TECHNICAL SERVICE BULLETIN

Subject: TSB for - New Style Transaxle Kit for the E17TD, E20DTD, E20CTD, E20S and E26ECO models.

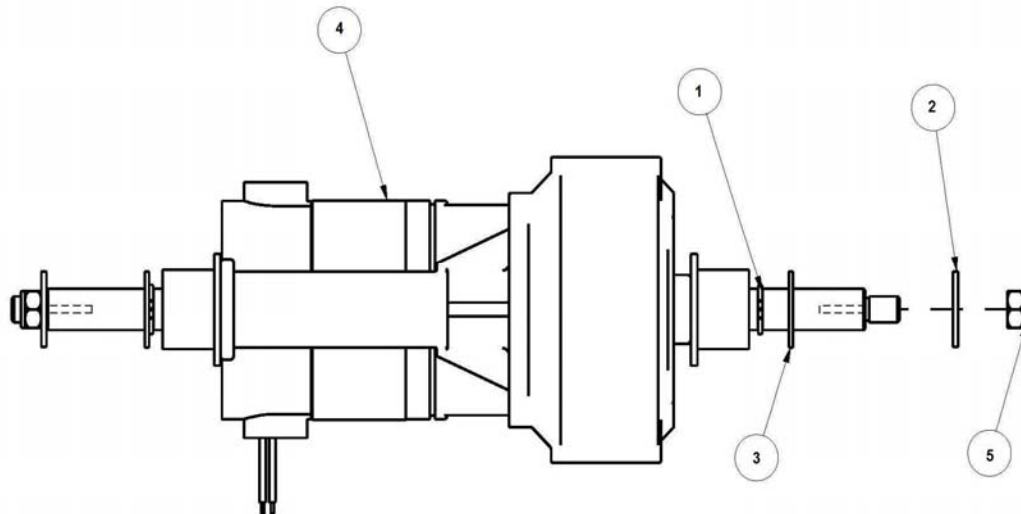
Improvement - The 747606 transaxles will now require a nut and different washers to mount the wheels instead of the bolts. The new kit was created so that the new wheel mounting hardware will be included.

Kit Instructions – The K747606 transaxle Kit will include the hardware shown below for mounting the wheels.

Order the kit when replacing the transaxle.
